September 15, 2010

Attn: Document Control Desk
Ron Linton
Project Manager
Uranium Recovery Licensing Branch
Division of Waste Management and
Environmental Protection
Office of Federal and State Materials and
Environmental Management Programs
U.S. Nuclear Regulatory Commission
Two White Flint North, MS T8F5
11545 Rockville Pike
Rockville, MD 20852

Re: Text Revisions to the Open Issues to the Safety Evaluation Report for the Nichols Ranch ISR
Project License Application (TAC J00553, Docket No 040-09067)

FIGURE D6D.1-1. WATER-LEVEL ELEVATION VERSUS TIME FOR WELLS MN-1, MN-2, MN-3, URZNB-1 AND URZN1-2

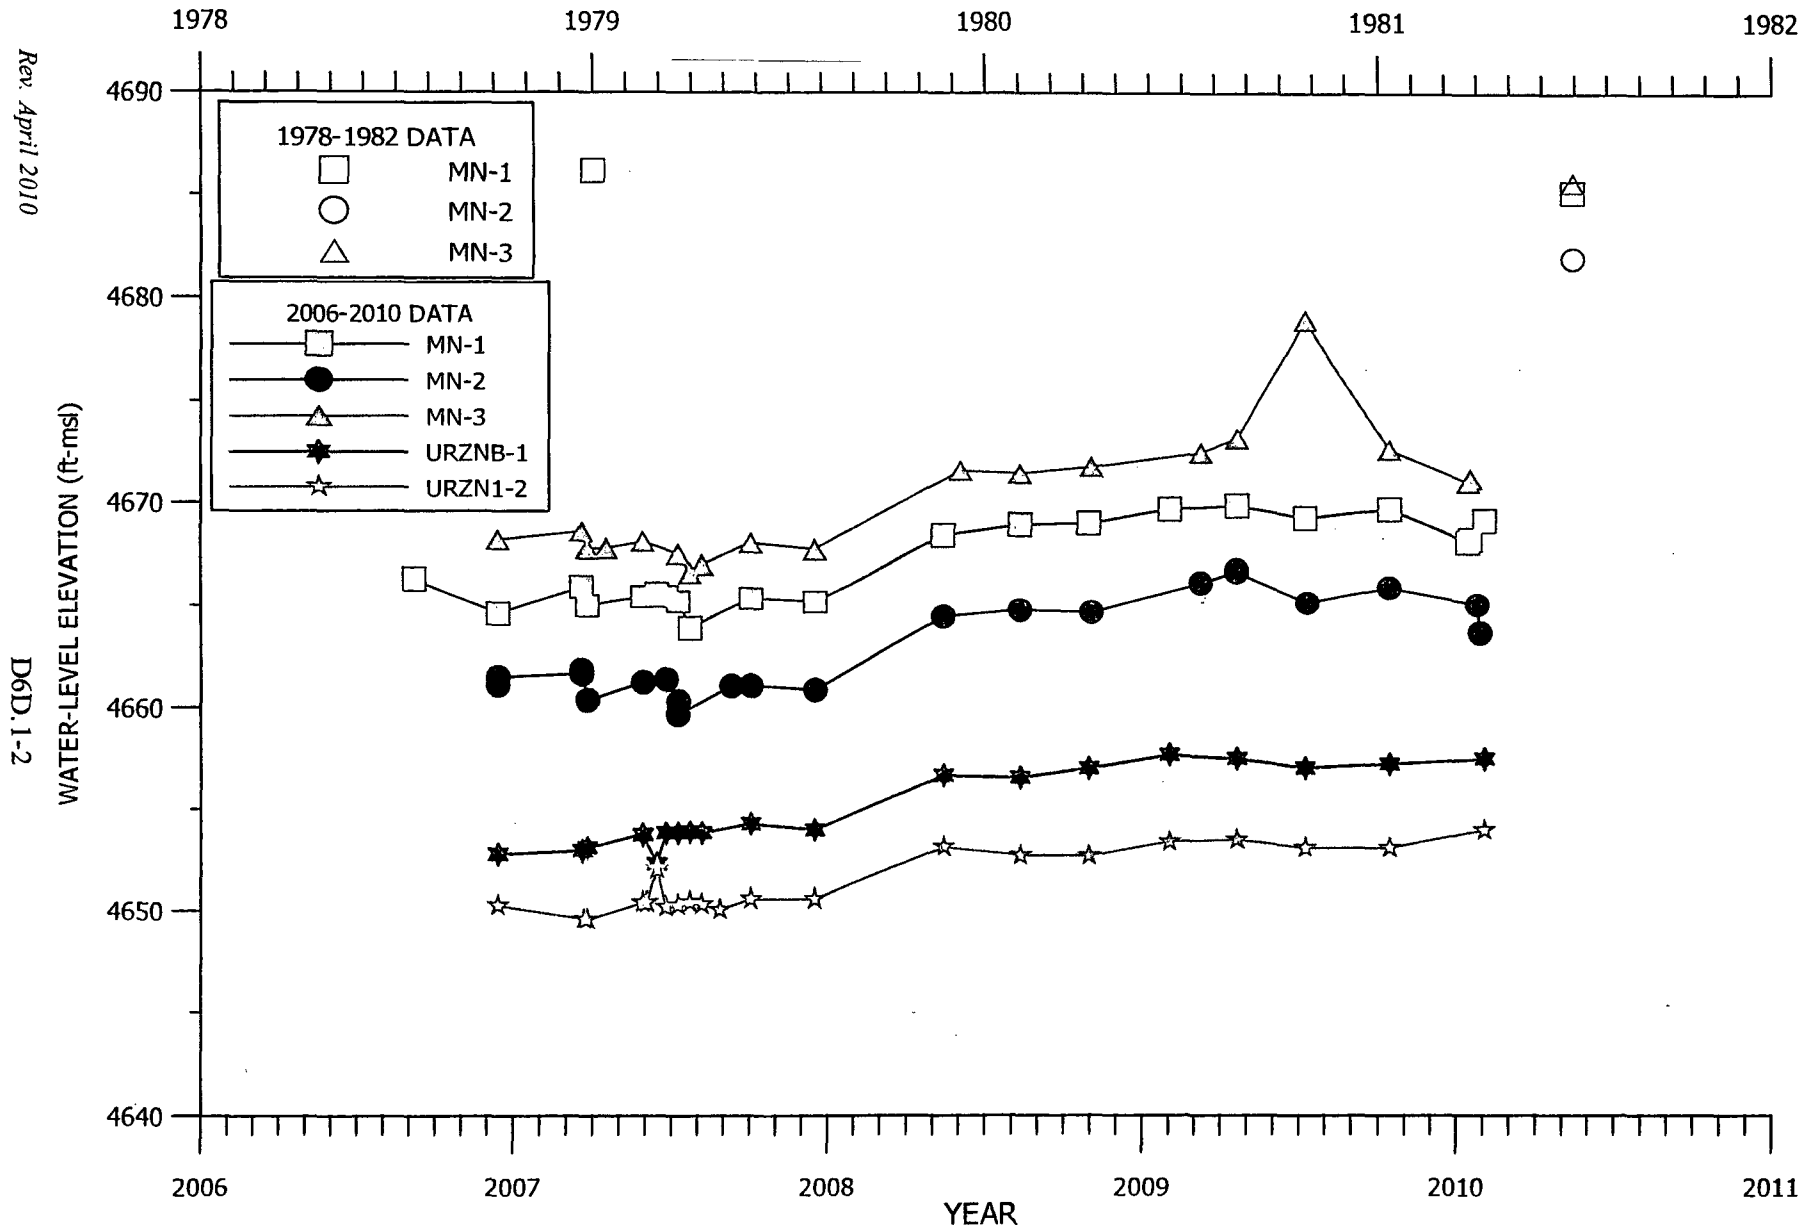
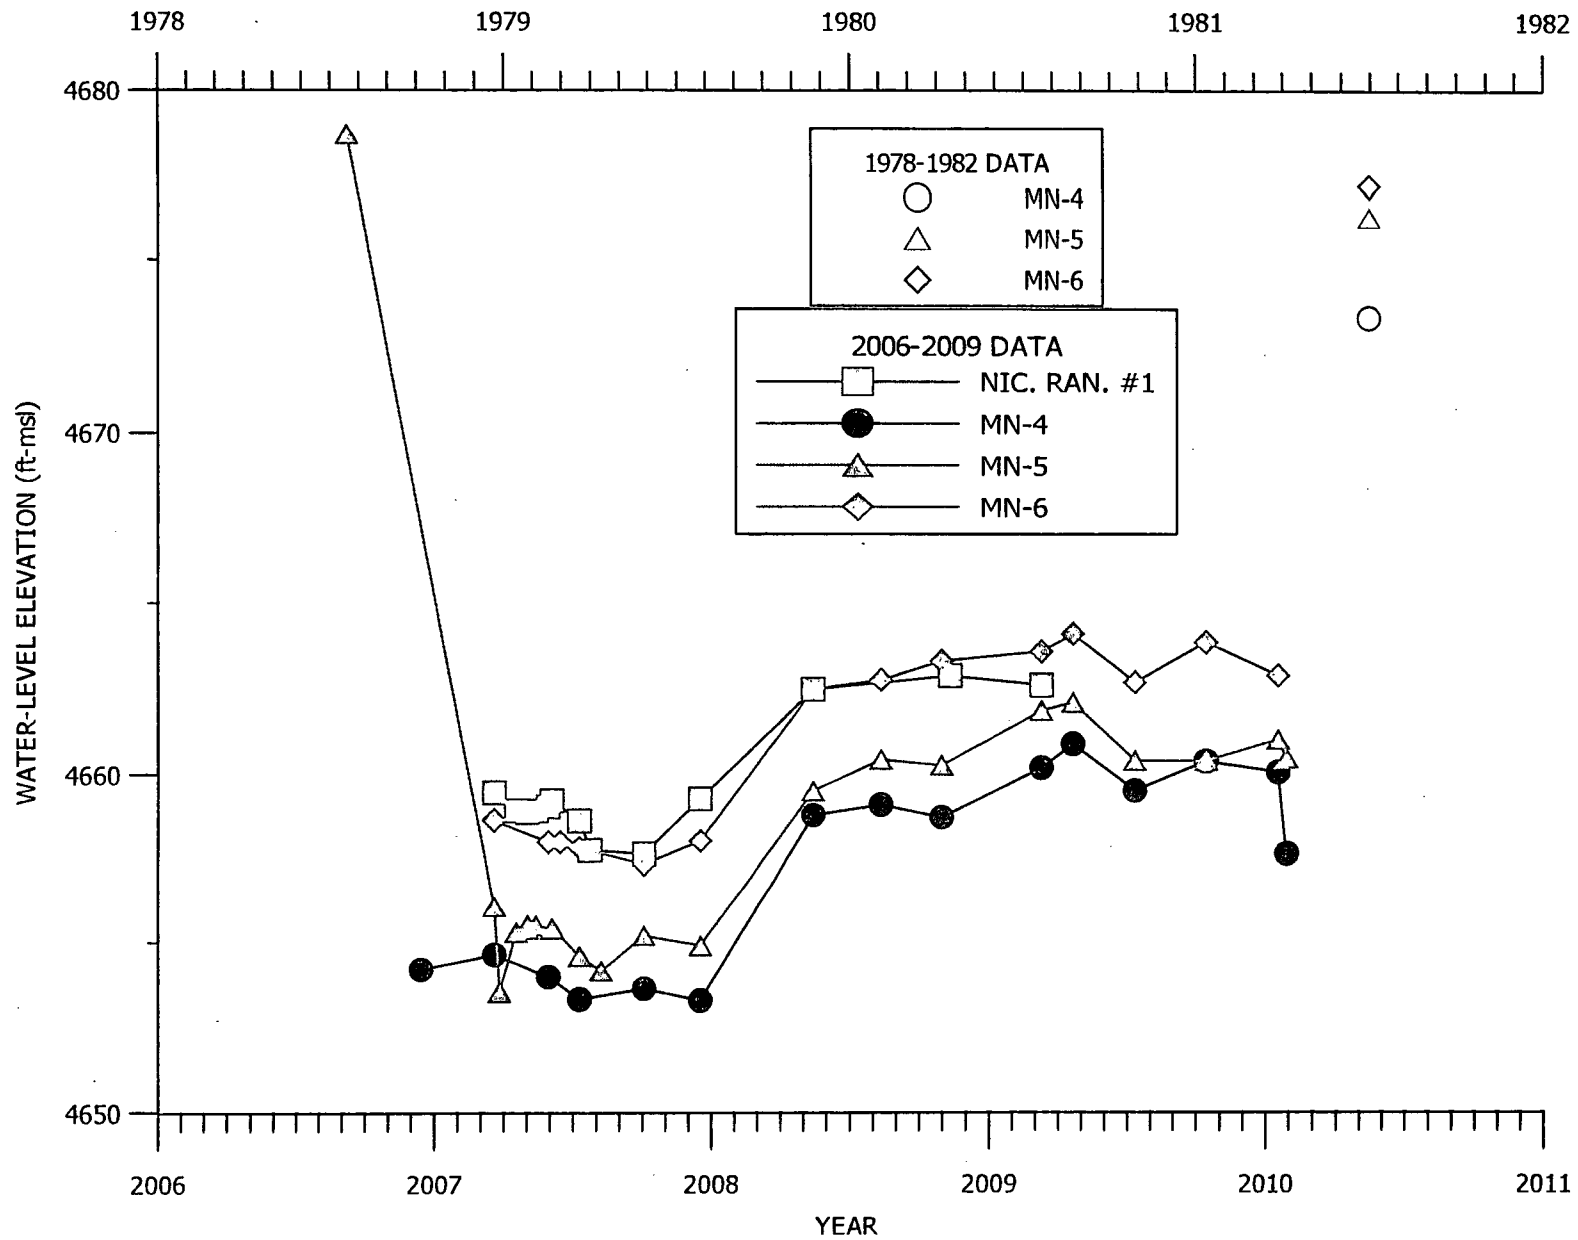
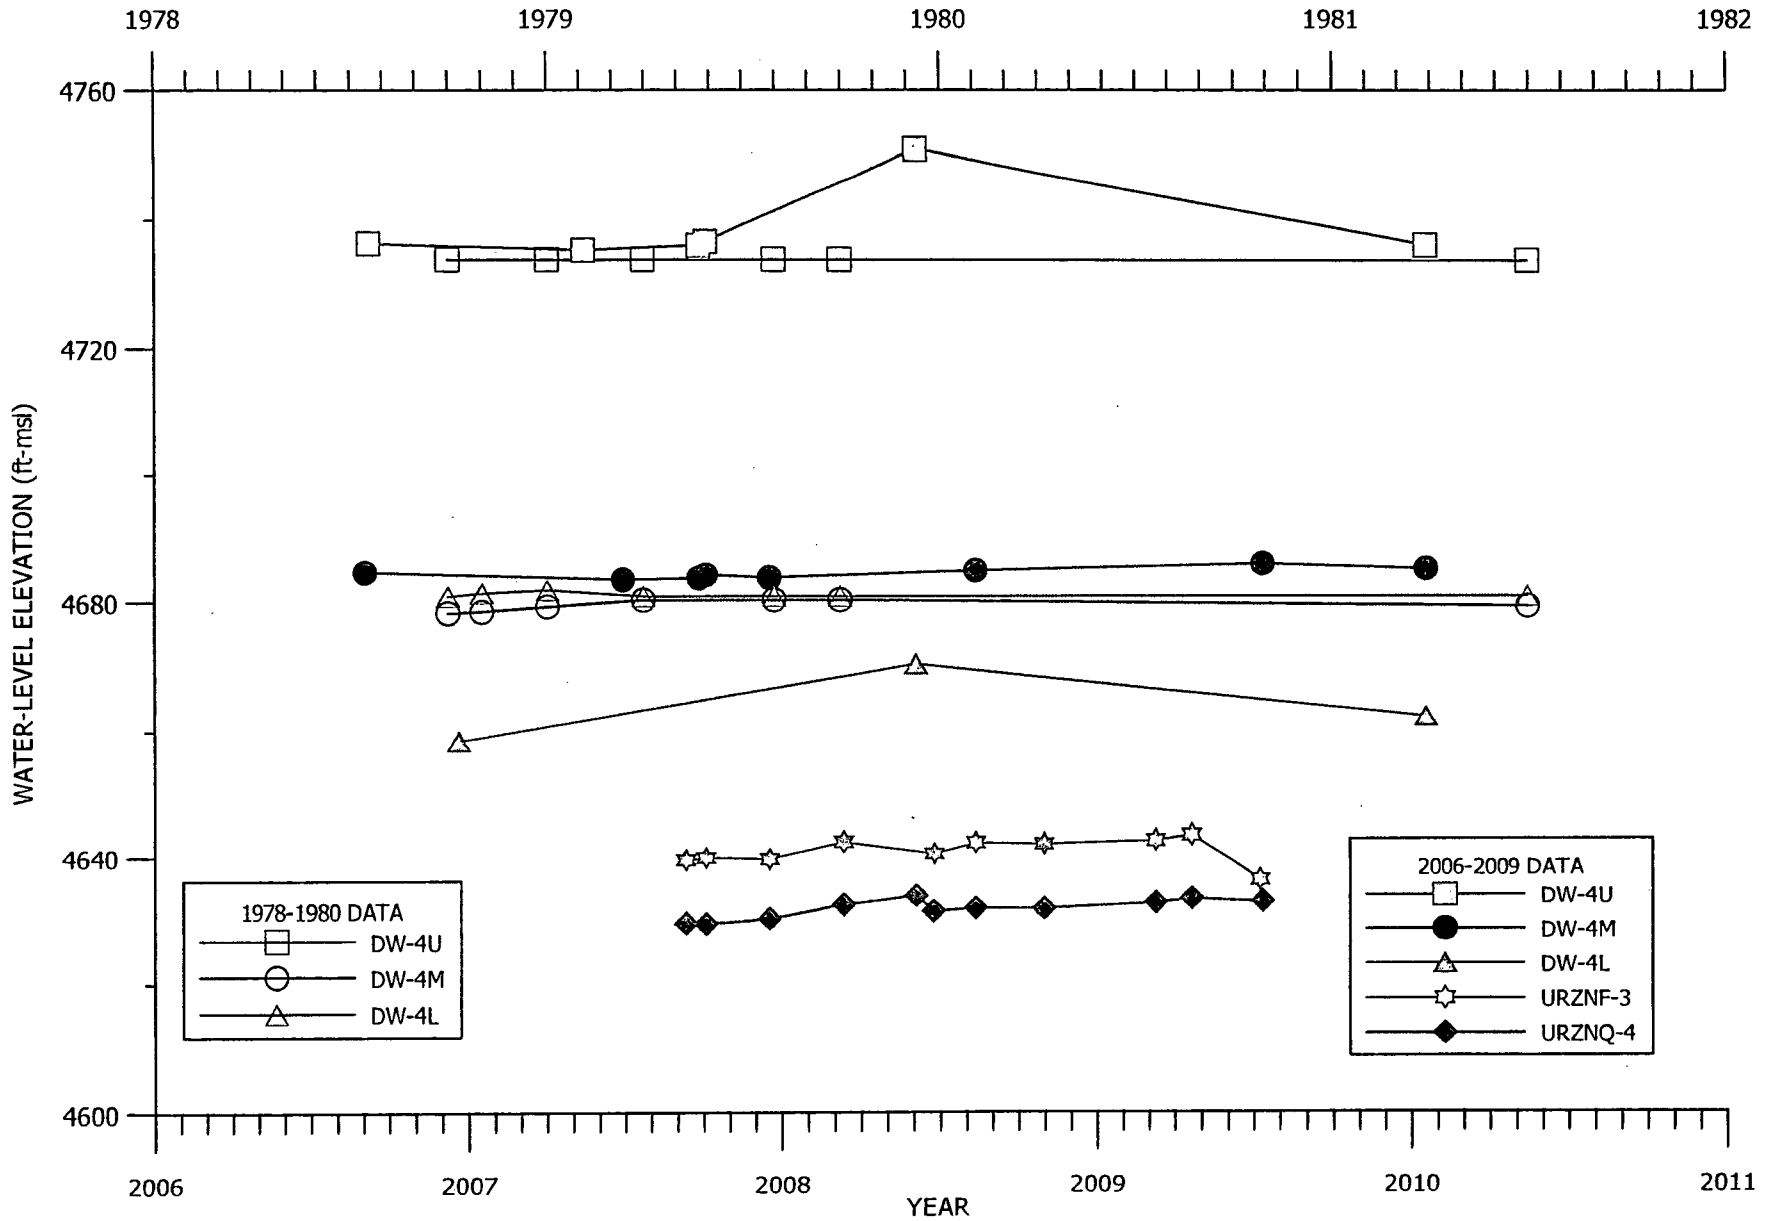
Volume Number	Page, Map or other Permit Entry to be REMOVED	Page, Map or other Permit Entry to be ADDED	Description of Change
Volume VI, Appendix D6, Addendum D6D	Figures D6D.1-1 through D6D.1-3, Aug 2009, pgs D6D.1-2 through D6D.1-4	Figures D6D.1-1 through D6D.1-3, April 2010, pgs D6D.1-2 through D6D.1-4	Figures revised to include updated and new water level information the Nichols Ranch Unit.
Volume VI, Appendix D6, Addendum D6D	Table D6D.1-1, Aug 2009, pgs D6D.1-5 through D6D.1-6	Table D6D.1-1, April 2010, pgs D6D.1-5 through D6D.1-6	Tables revised to included updated and new water level information.
Volume VI, Appendix D6, Addendum D6D	Figures D6D.2-1 through D6D.2-3, Aug 2009, pgs D6D.2-2 through D6D.2-4	Figures D6D.2-1 through D6D.2-3, April 2010, pgs D6D.2-2 through D6D.2-4	Figure revised to include updated and new water level information.
Volume VI, Appendix D6, Addendum D6D	Table D6D.2-1, Aug 2009, pgs D6D.2-7 through D6D.2-11	Table D6D.2-1, April 2010, pgs D6D.2-7 through D6D.2-11	Table revised to include updated and new water level information for the Hank Unit.
